Access Compliance Report Public Rights-of-Way (Curb Ramps)

Main Street: CHIQUITA_CANYON_DR		Cross Street: ESENCIA_DR		Location:	NW
ADA ID: RPRK211124132249	Ramp Type:Type 1 - Perpendicular Diagonal Initial Pass/Fail: Fail		Overall Compliance: No	Severity Score:	2

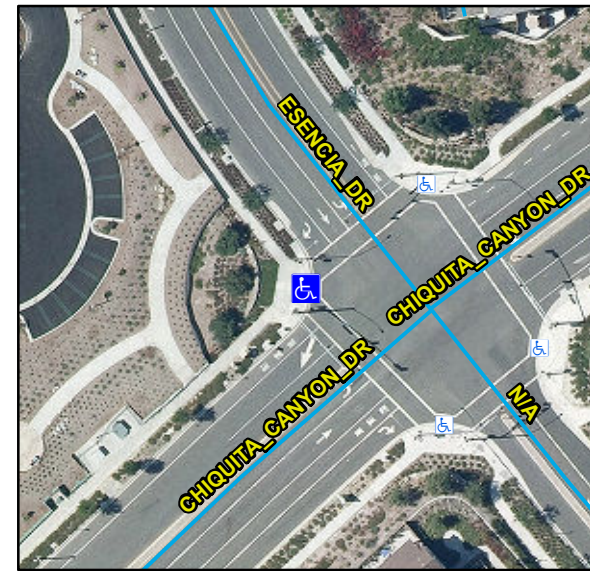
R304.2.2, R304.5.3, STD 1115

Remove & Replace Curb Ramp With Two New Directional Ramps or Equivalent.
